BULLETIN NO. 2

Rocky Hill Intermediate School – Phase 2, Rocky Hill, CT

Rocky Hill Intermediate School Pre-Bid RFI Log – Bulletin 002
Updated: March 21, 2018

13 3/4" CRUSHED STONE SURFACE
SCALE: N.T.S.

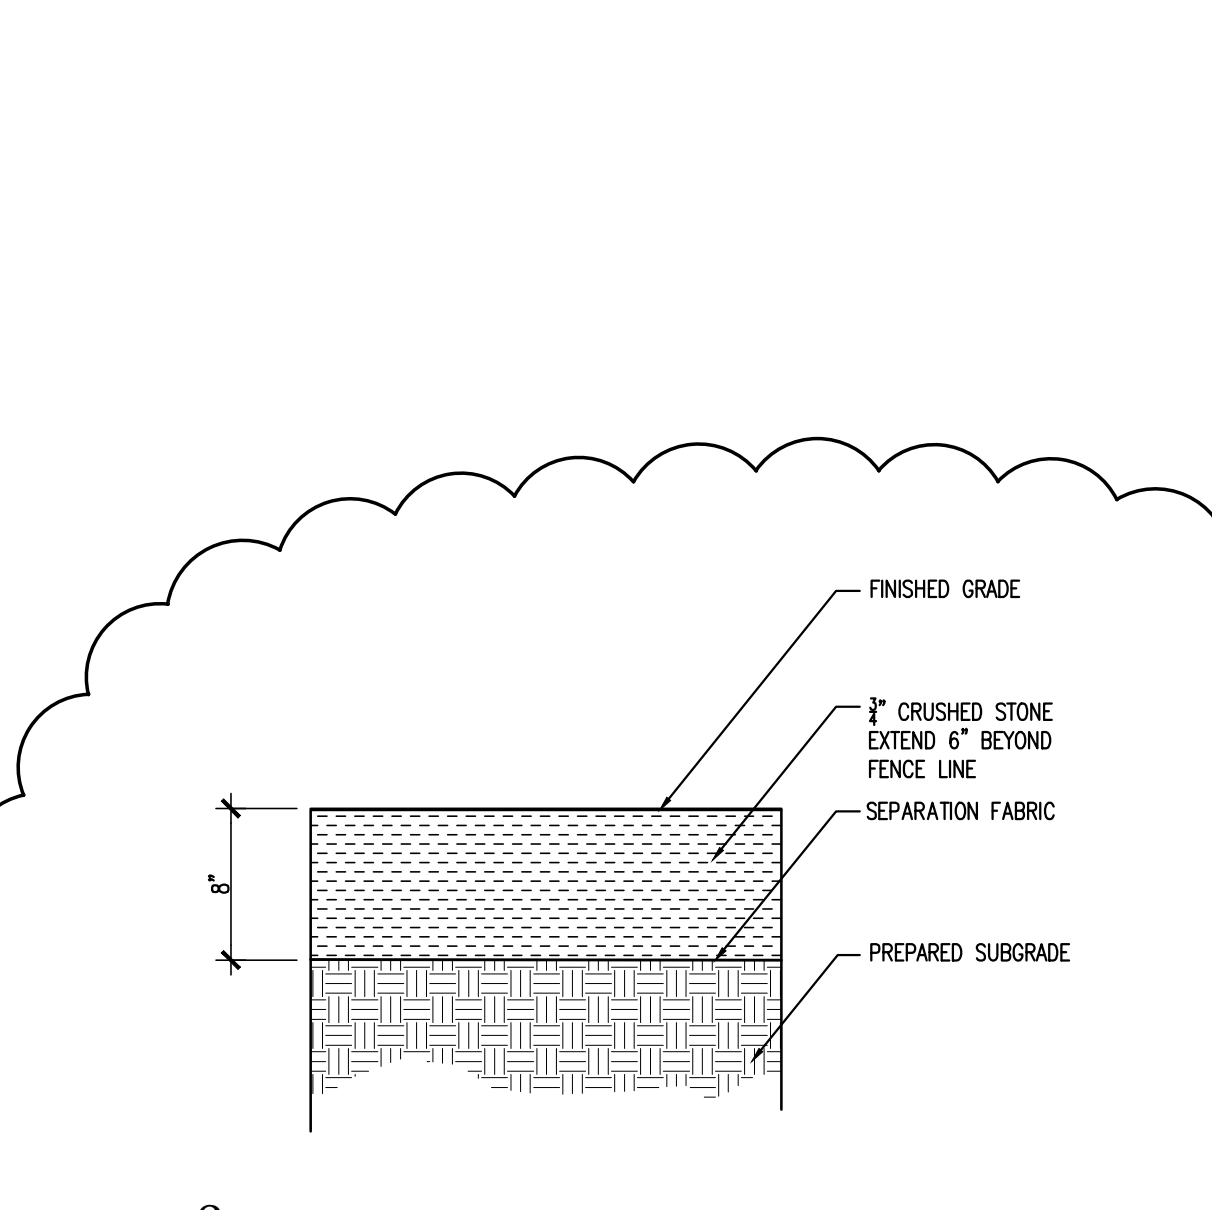
Add Detail #13, “3/4” Crushed Stone Surface”.

DRAWING NO.:
S4.03

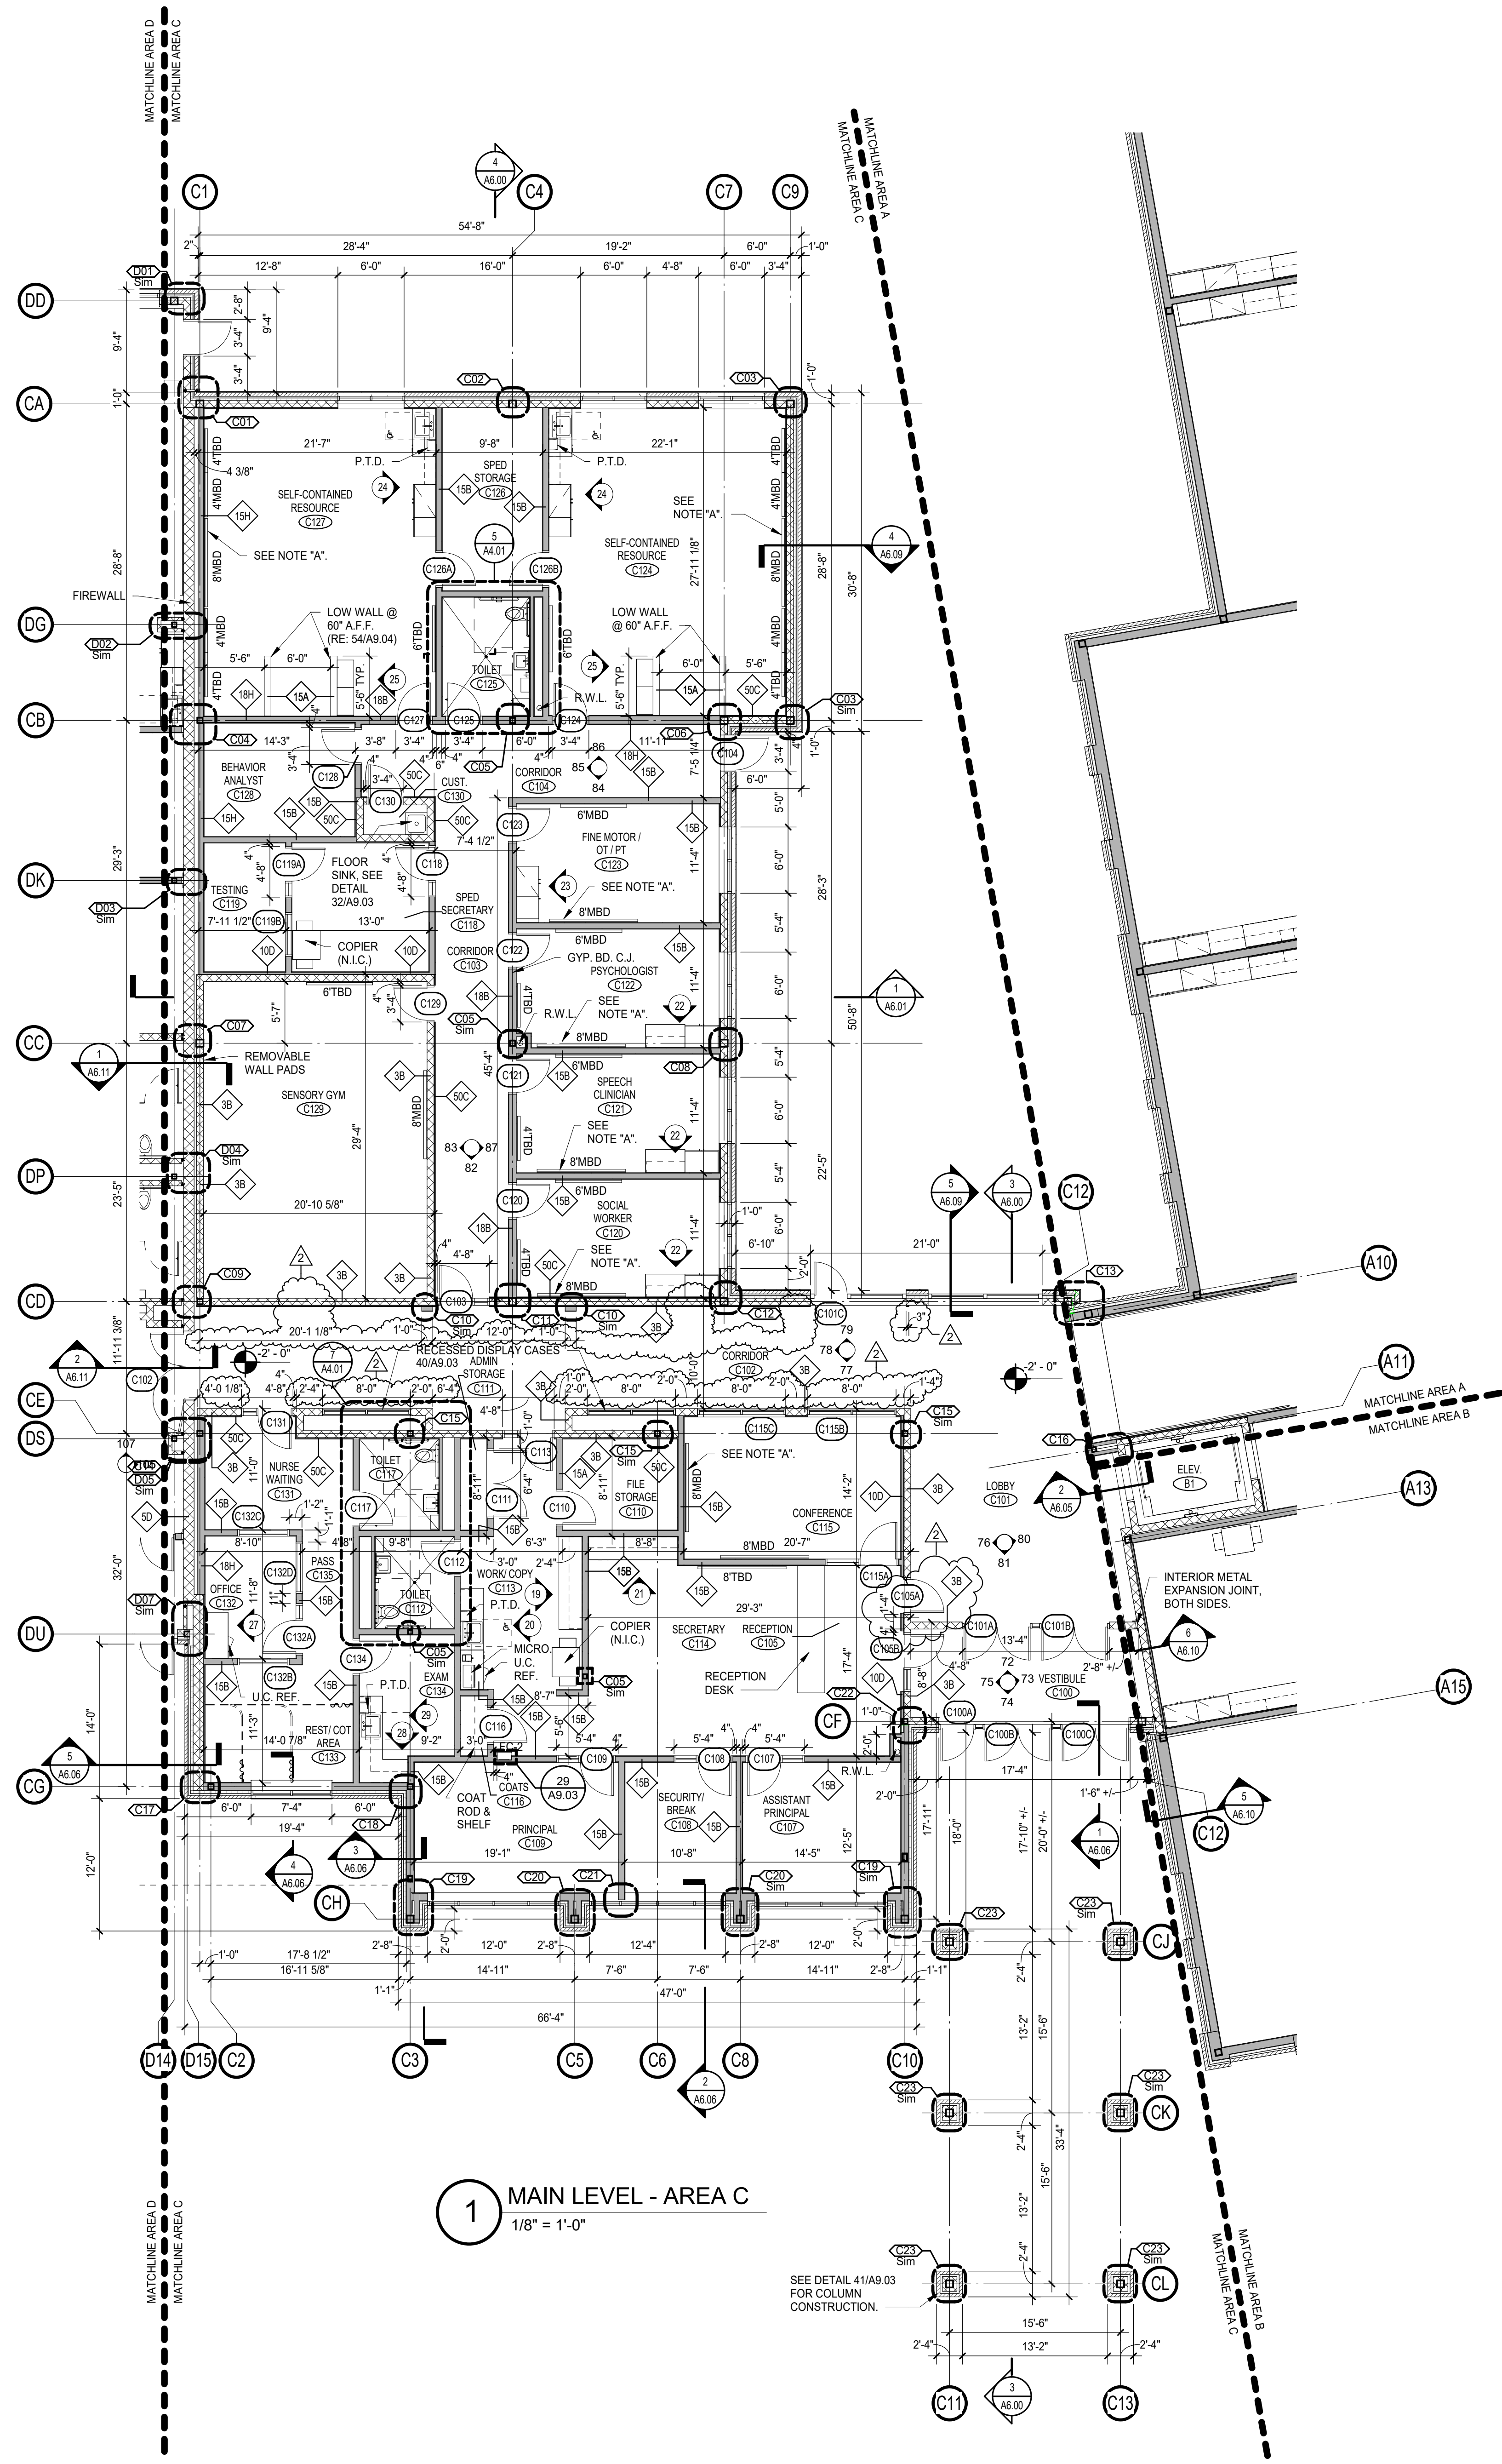
See revised full size Drawing S4.03 for changes to braced frame elevations.

**ELECTRICAL
LIGHTING
MAIN LEVEL -
AREA C**
DRAWING NO.:
E1.03

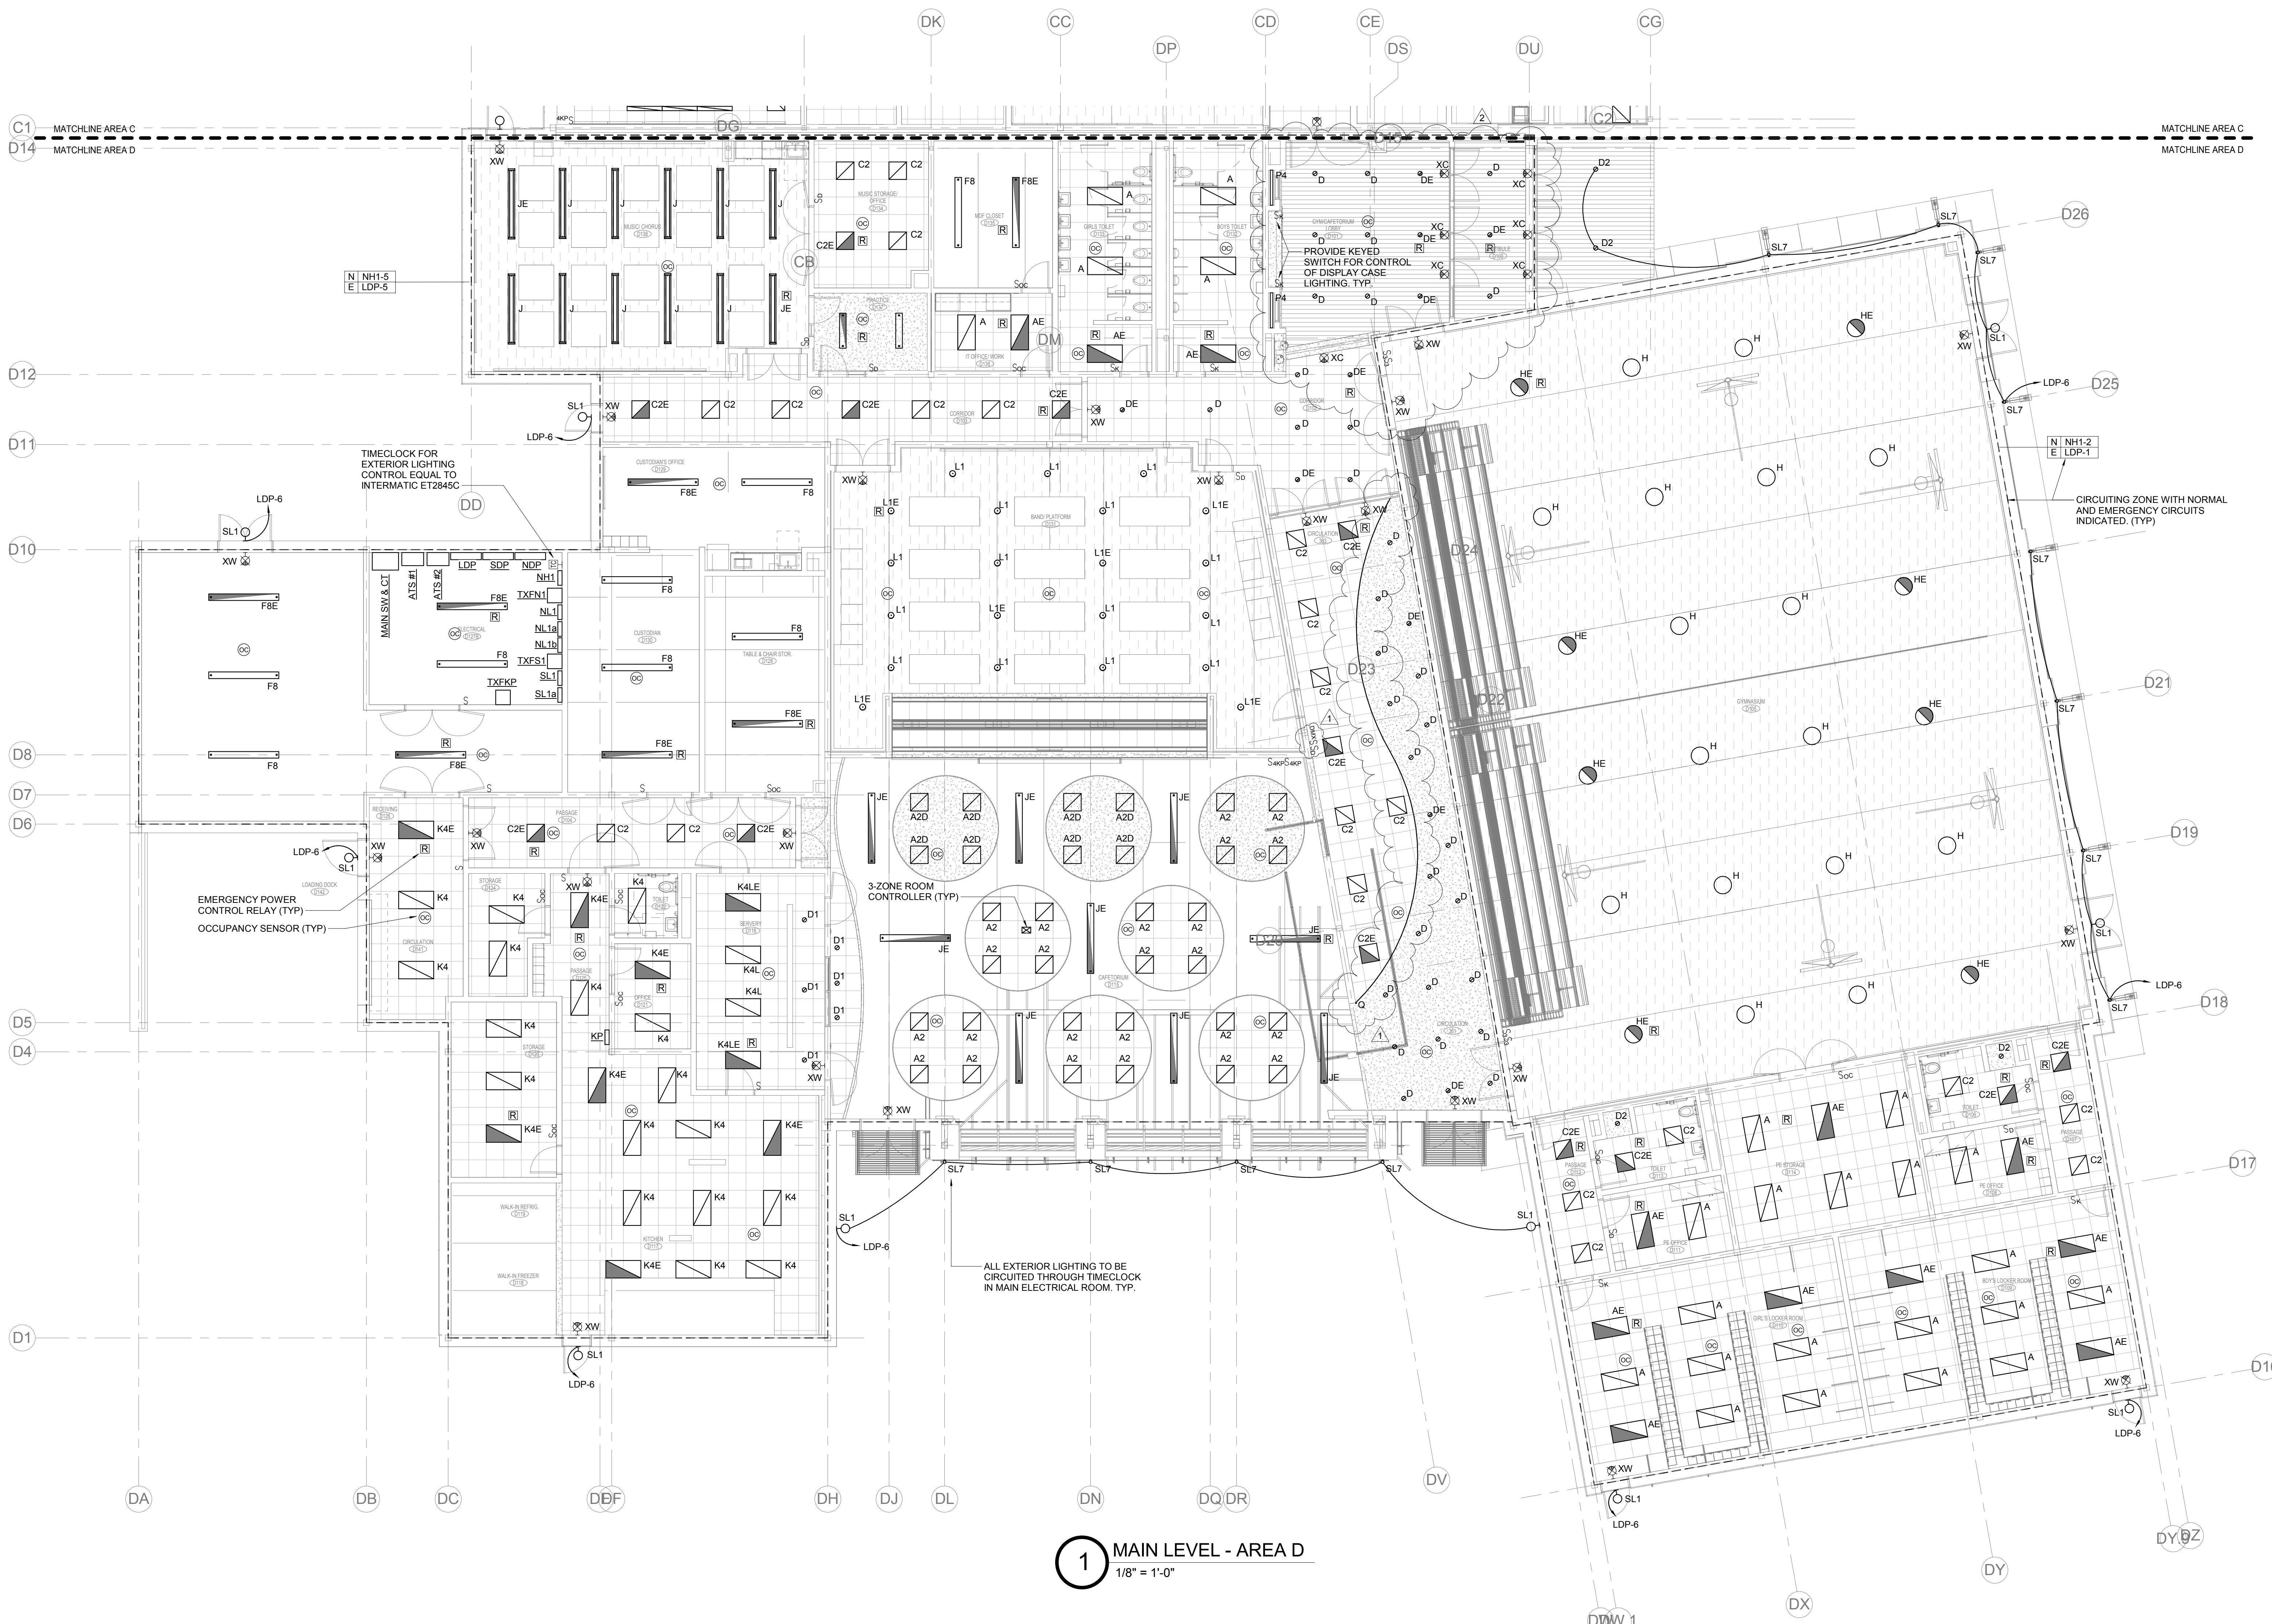
E1.03 ELECTRICAL LIGHTING MAIN LEVE – AREA C
Revise corridor C102 ceiling lighting layout.
